March 6, 2018

Product Change Notice - Solid Formed Crossmember(s) Revision

Fig.2

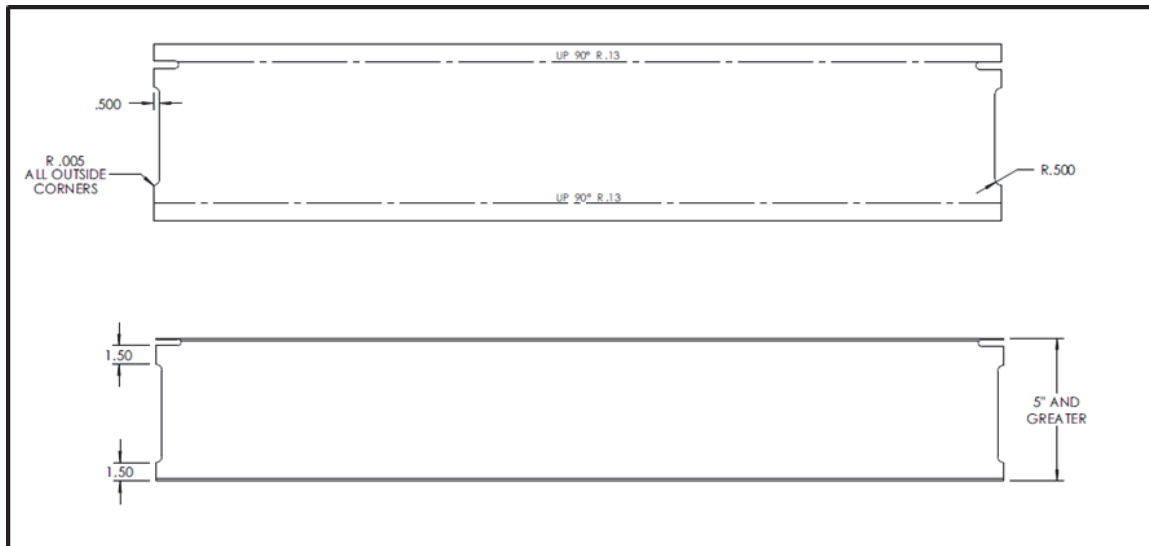
Currently LCI Chassis Division fully welds (Fig. 1) the vertical portion of the crossmember to the webbing of the I-Beam. The revised version of our solid formed crossmember will have .50" (Fig. 2) recessed notches on either side.

The foremost benefit is increased powder coverage due to the minimized Faraday Cage effect. The new notches will allow for blast media and powder coat to flow through the opening creating a better surface to powder and more even powder coverage.

The layout of the notches will vary by height of crossmember as shown in Figure 2 and noted below.

- Crossmembers 5.00" – 11.5" in height
 - A singular notch in the center of the crossmember creating 3" of vertical surface area welded to the I-Beam web.

Fig.3

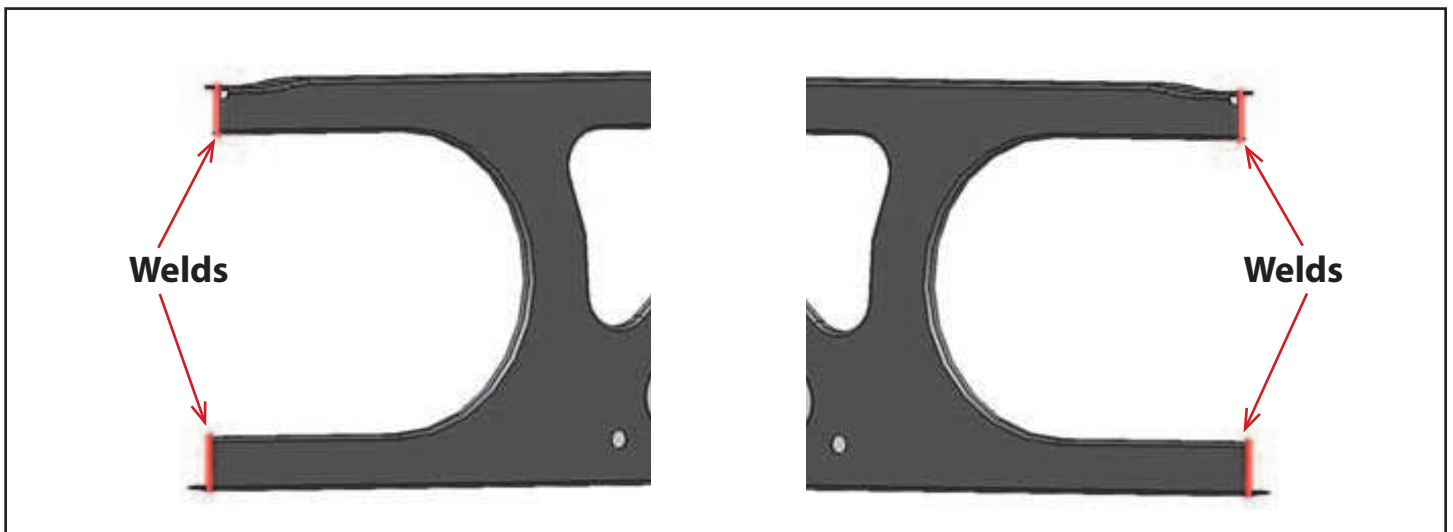
The vast majority of our current crossmembers have openings for duct work and/or other items to travel along the web of the chassis. With these crossmembers we weld the two 1.5" vertical surface areas (Fig. 3) to the webbing of the I-Beam without incident. The newly created notches on our solid crossmembers will mirror the weld specifications on our more traditional road and angle crossmembers. This will help to promote consistency in our welding processes and raise the quality of the product delivered to your facility.
